Sunshine Coast Airport Flight Path Changes Post Implementation Review (PIR)

DRAFT REPORT

Effective Date: 09 February 2023

Position the RWY 13 – RNP W (AR) APPROACH (shorter approach) equally between Marcus Beach and Castaways Beach

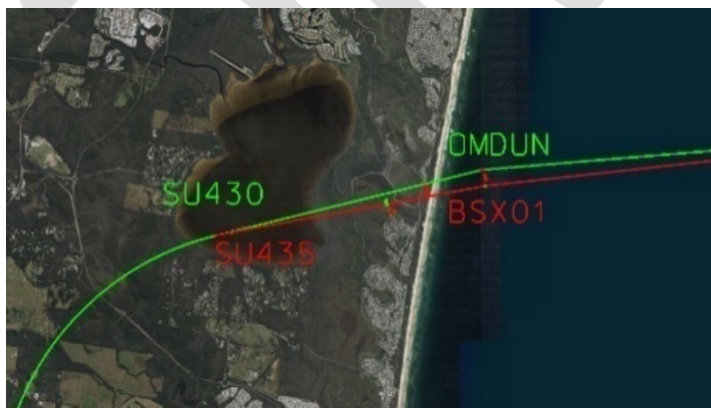
Current RWY 13 RNP-AR approach begins at waypoint OMDUN (green). The approach can be adjusted to the South by 320m to begin at waypoint BSX01 (red). This would provide an equidistant split of ~275m/15NM between the residential areas of Castaways Beach to the south and Marcus Beach to the north, providing more equitable noise sharing.

Further design required to confirm no flow- on effect to procedures prior to or after the location of this proposed change. Subject to community engagement.

C.1.9 Increase sharing of RNP W RWY 13 (AR) with RNP Z RWY 13

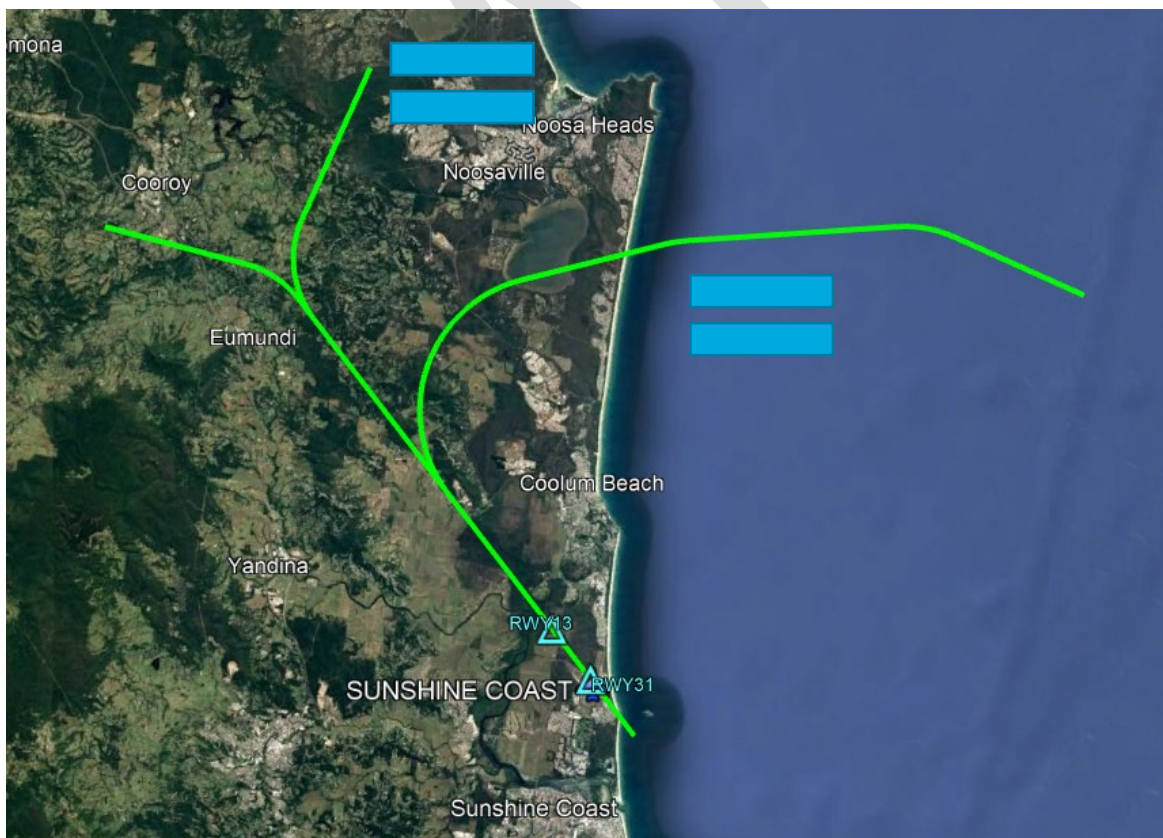
Assessment Criteria	Does the change?	Assessment Outcome	Justification
Safety and Operational Compliance	Comply with international and national safety and design standards	Yes	Safe and compliant.
Operational efficiency and feasibility	Increase complexity to operations (the work of ATC in managing the air space or pilot workload in flying the flight path)	Yes	Increase ATC workload on monitoring equal distribution of aircraft on arrival flight tracks. Increase pilot workload to brief the approach.
	Is the change flyable and efficient Increase track miles for industry (impacting emissions and operational cost)	Yes	On average there is an additional 11nm in track miles using the RNP Z RWY13 flight path as opposed to the RNP-W RWY13 (AR) flight path. Aircraft use the RNP W RWY 13 (AR) due to the track mile, CO2, and flight time savings it offers over the longer RNP Z RWY 13 flight path. Aircraft use the RNP Z RWY 13 approach without required authorisation/equipment to fly the AR or when operationally required for sequencing.

Environmental	Is the change environmentally appropriate? Reduce noise levels or the number of people impacted	No	1,500 population under RNP W RWY 13 (AR) 2,600 population under RNP Z RWY 13 Will lower the number of aircraft over the communities under the RNP W RWY13 (AR) flight path, however, will transfer aircraft operations to the communities under the RNP Z RWY13 flight path. This will increase the number of exposed population by 1,100 per arrival and increase the number of arrivals by three up to seven arrivals on an average day for communities under the RNP Z RWY13 flight path. This results in a reduction of the number of arrivals by three down to seven arrivals on an average day for communities under the RNP W RWY13 (AR) flight path.
	Affect new communities	No	This suggested change utilises existing procedures. No new flight paths.

Assessment Criteria	Does the change?	Assessment Outcome	Justification
	Better share the impact of noise in keeping with our Flight Path Design Principles	Yes	The increased usage of the RNP Z RWY13 will better share aircraft operations with the RNP-W RWY13 (AR).
	Result in greater track miles for industry (and thus greater emissions)	Yes	On average there is an additional 11nm in track miles using the RNP Z RWY13 flight path as opposed to the RNP-W RWY13 (AR) flight path per arrival. This results in an additional 64kg of fuel burn and 200kg of CO ₂ emissions per arrival. (Depending on type of aircraft).
	Impact areas of national environmental significance and noise sensitive sites	No	This suggested change utilises existing procedures. No new flight paths.
	Impact areas of future residential development or areas of high tourism value	No	This suggested change utilises existing procedures. No new flight paths.

Network	Have flow on effects or require changes to other procedures or flight paths	No	No change to existing flight paths.
	Impact or benefit overall network efficiency	Impact	Reduction in efficiency to manage equal approach distribution. Less optimised sequencing. Increased likelihood of holding.
	Involve a cost	No	No change to existing flight paths.
	Have a benefit appropriate to the cost	Yes	This change may provide community benefit.

Assessment outcome: The suggestion to increase sharing of RNP W RWY 13 (AR) with RNP Z RWY 13 is best achieved through NAPs and will progress for further assessment.

C.1.12 Reduce the RNP W RWY 13 (AR) tolerance from RNP 1.0

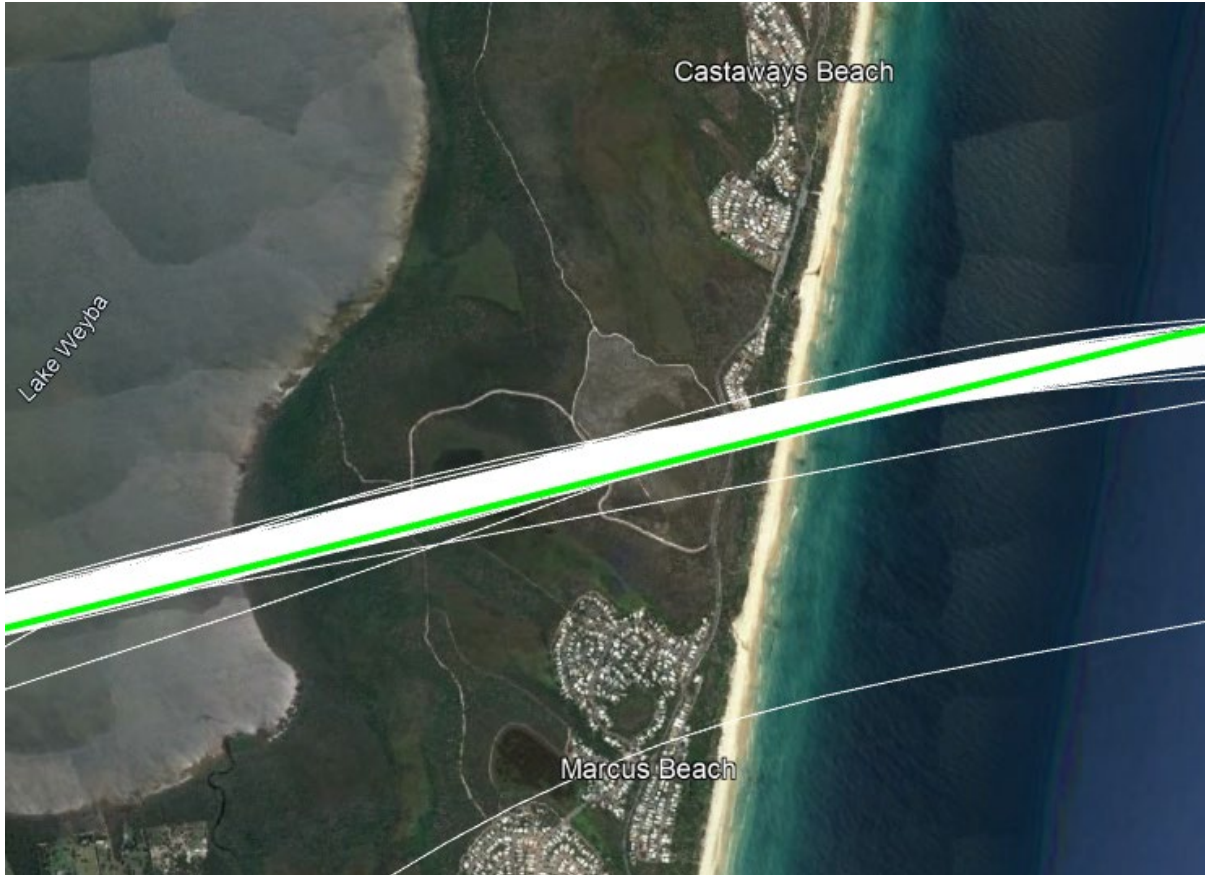
Assessment Criteria	Does the change?	Assessment Outcome	Justification
Safety and Operational Compliance	Comply with international and national safety and design standards	Not safe and compliant	A reduction of the RNP tolerance from RNP 1.0 to RNP 0.3-0.1 is nonstandard for the initial segment of an RNP-AR approach as outlined in CASA MOS 173. It must also be noted that tightening tolerances will not make aircraft fly more accurately, only notify them when they cannot meet the required accuracy. The system already flies a very tight tolerance along the line and aims to be exactly on the line, regardless of RNP value.

Assessment outcome: Reducing the RNP approach tolerances will not progress for further assessment. The above image is a snapshot of all RNP W RWY 13 (AR) operations (white tracks) for the period 01/01/2022 – 30/06/2022, the green line is the nominal RNP W RWY 13 (AR) flight path. The furthest extent of standard RNP-AR flight tracks is approximately 180m north of track, within an RNP 0.1 tolerance.

C.1.13 Adjust the RNP W RWY 13 (AR) arc further northwest

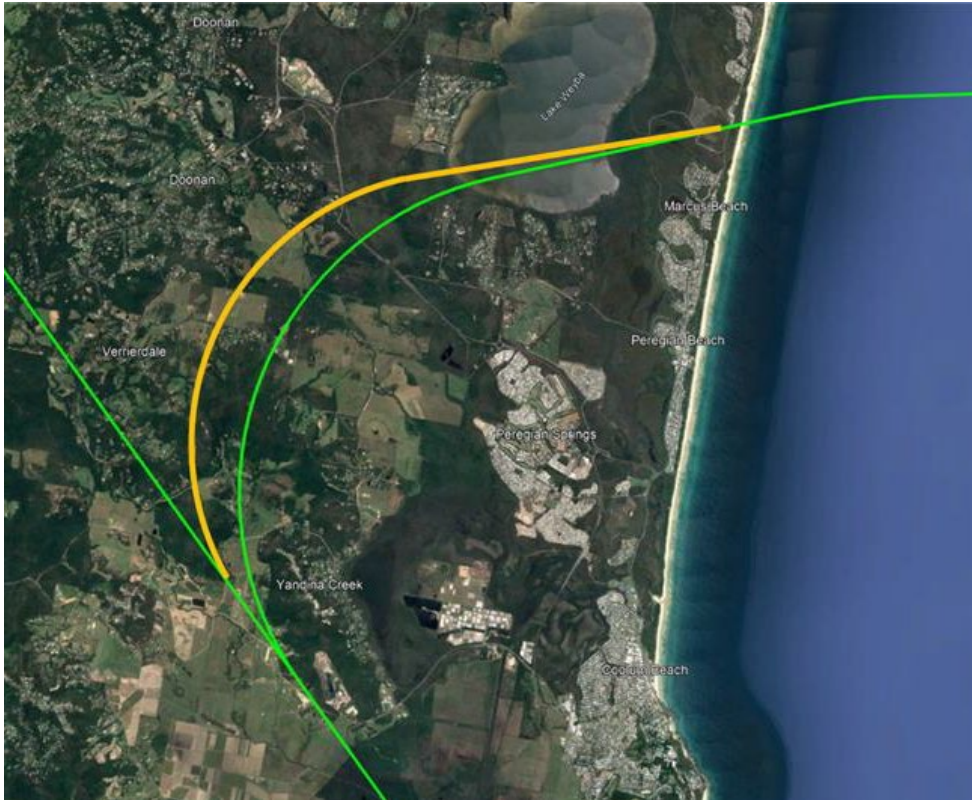
Assessment Criteria	Does the change?	Assessment Outcome	Justification
Safety and Operational Compliance	Comply with international and national safety and design standards	Yes	Safe and compliant.
Operational efficiency and feasibility Is the change flyable and efficient	Increase complexity to operations (the work of ATC in managing the air space or pilot workload in flying the flight path)	No	The adjustment will not increase the complexity of operations.
	Increase track miles for industry (impacting emissions and operational cost)	No	No material differences in track miles.
Environmental Is the change environmentally appropriate?	Reduce noise levels or the number of people impacted	No	1,500 population under the existing RNP W RWY 13 (AR) 1,600 population under the suggested RNP W RWY 13 (AR)

Assessment Criteria	Does the change?	Assessment Outcome	Justification
			Will remove aircraft over the communities under the existing RNP W RWY 13 (AR) flight path, however, will transfer aircraft operations to the communities under the suggested flight path further northwest and will expose an extra population of 100 per arrival.
	Affect new communities	Yes	This suggested change will move the track more over Doonan.
	Better share the impact of noise in keeping with our Flight Path Design Principles	No	The suggested change will only transfer aircraft operations from the existing RNP W RWY13 (AR) flight path.
	Result in greater track miles for industry (and thus greater emissions)	No	No material differences.
	Impact areas of national environmental significance and noise sensitive sites	No	This suggested change will overfly Lake Weyba and Coolum Creek and Lower Maroochy River. This currently is overflowed by the existing RWY13 RNP-W (AR) flight path.

Assessment outcome: This suggestion will not progress for further assessment as it would not provide benefit to the community due to the shifting of noise.

C.1.15 Remove OLTUD Initial Approach Fix (IAF) of the RNP Z RWY 13

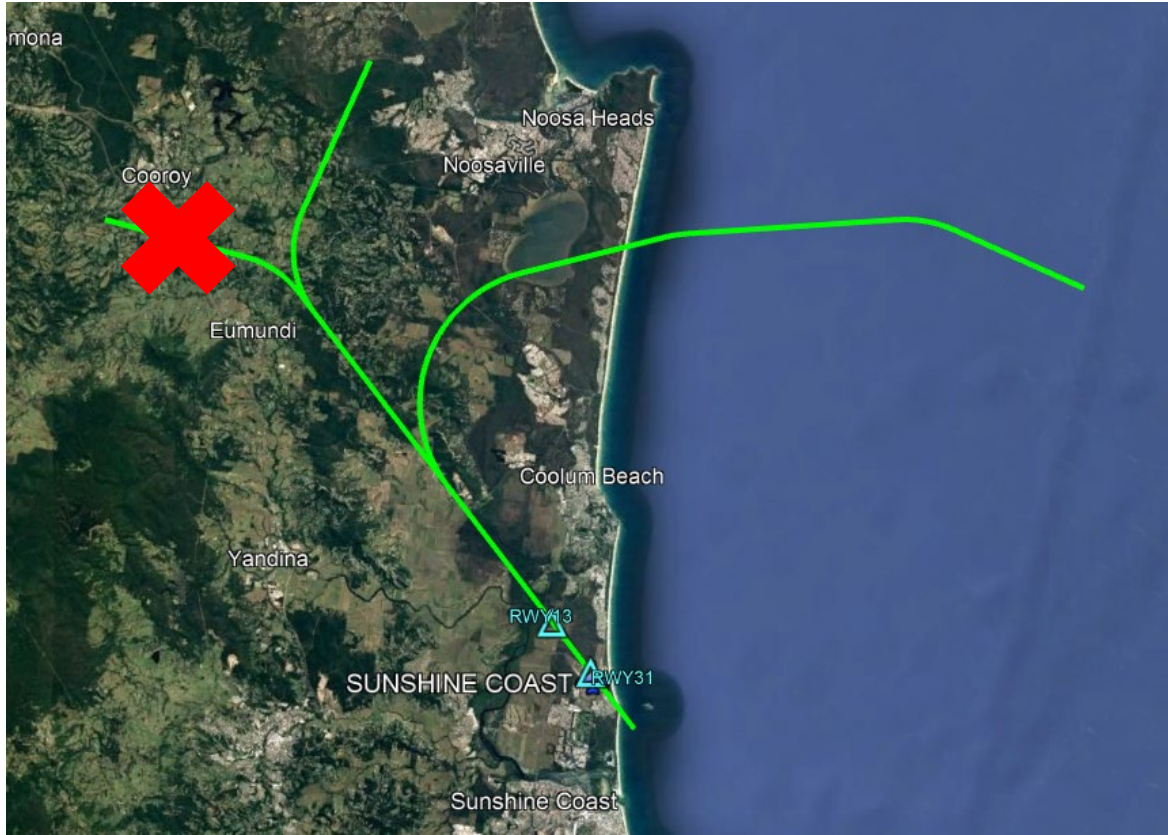
Assessment Criteria	Does the change?	Assessment Outcome	Justification
Safety and Operational Compliance	Comply with international and national safety and design standards	Yes	Another IAF would need to be designed in a similar location.
Operational efficiency and feasibility	Increase complexity to operations (the work of ATC in managing the air space or pilot workload in flying the flight path)	Yes	Would require ATC to track aircraft to join the RNP Z RWY 13 from a less efficient location. May increase pilot workload to track to an alternative location.
	Is the change flyable and efficient Increase track miles for industry (impacting emissions and operational cost)	No	No material differences.
Environmental	Is the change environmentally appropriate? Reduce noise levels or the number of people impacted	No	3,600 population under RNP Z RWY13 (to SUSGI via OLTUD).
			12,400 population under RNP Z RWY13 (to SUSGI via suggested change).

Assessment Criteria	Does the change?	Assessment Outcome	Justification
			Removing the RWY13 RNP-Z flight path via OLTUD initial Approx Fix and utilising a new approach will expose an extra population of 8,800 per arrival out to SUSGI. Based on the last six months, this will shift 300 operations in a six-month period or around an extra two arrivals per day onto this new approach.
	Affect new communities	Yes	This suggested change utilises new procedures and new flight paths which will likely affect new communities.
	Better share the impact of noise in keeping with our Flight Path Design Principles	No	The suggested change will only transfer aircraft operations from the existing RNP Z RWY13.
	Result in greater track miles for industry (and thus greater emissions)	No	No material differences.
	Impact areas of national environmental significance and noise sensitive sites	No	This suggested change will overfly Coolum Creek and Lower Maroochy River and within a buffer zone for the Great Sandy Straight RAMSAR Wetlands.

Assessment Criteria	Does the change?	Assessment Outcome	Justification
	Have a benefit appropriate to the cost	No	This change would impact operational efficiency, impact new communities, and involve a cost to industry.

Assessment outcome: The suggestion to remove OLTUD Initial Approach Fix (IAF) of the RNP Z RWY 13 will not progress for further assessment due to the impacts on new communities and operational efficiency.

C.1.19 Rotate the SID MOOLO ONE RWY 13 to the north, to track aircraft east over the ocean

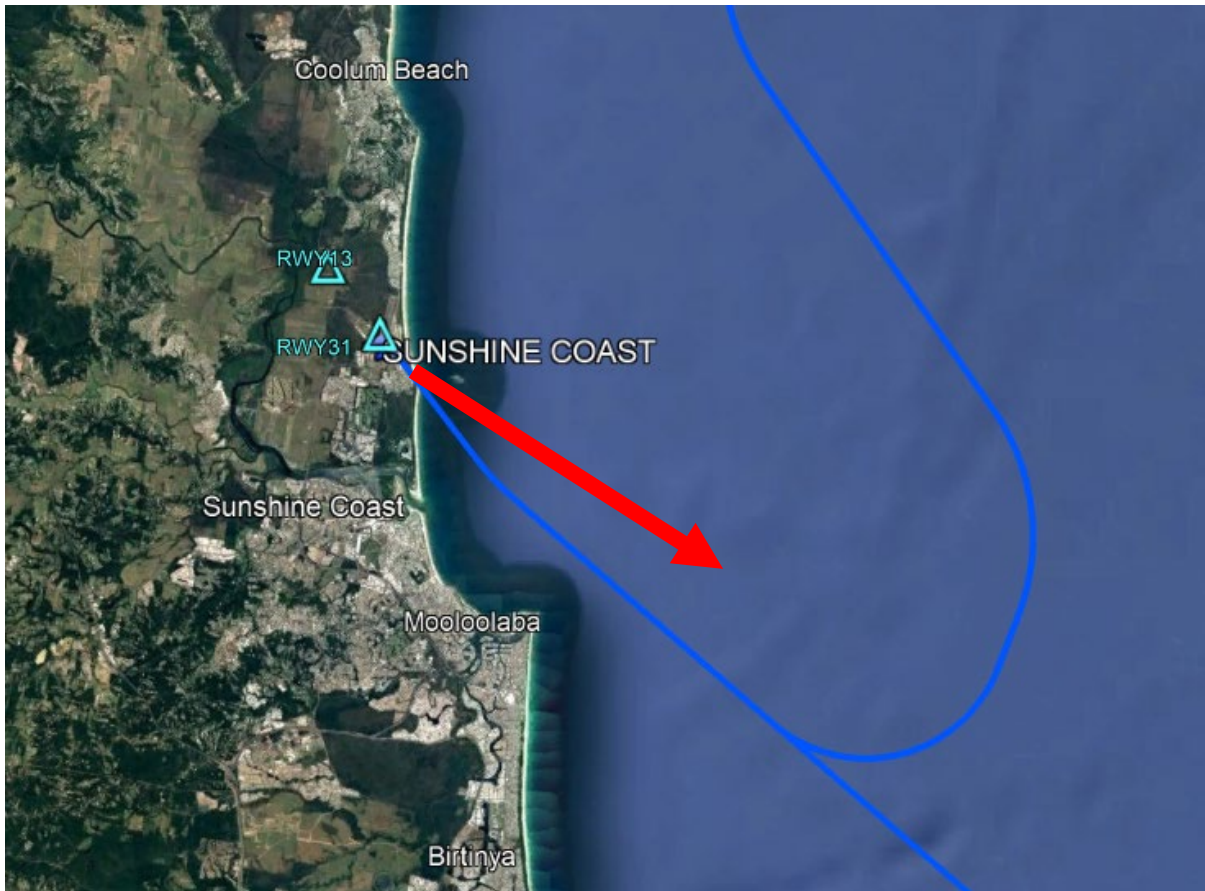
Assessment Criteria	Does the change?	Assessment Outcome	Justification
Safety and Operational Compliance	Comply with international and national safety and design standards	Yes	Significant redesign would be required to ensure the proposal is safe and compliant.
Operational efficiency and feasibility	Increase complexity to operations (the work of ATC in managing the air space or pilot workload in flying the flight path)	Yes	Increase complexity for ATC to separate the SID MOOLO ONE RWY 13 from the SID TAPET ONE RWY 13 by introducing a track crossover.
Is the change flyable and efficient	Increase track miles for industry (impacting emissions and operational cost)	No	No material differences.
Environmental	Reduce noise levels or the number of people impacted	No	No material differences.

Assessment outcome: The suggestion to rotate the SID MOOLO ONE RWY 13 to the north, to track aircraft east over the ocean will not progress for further assessment due to the negligible benefit to the community and impact on operational efficiency/flow on network impacts.
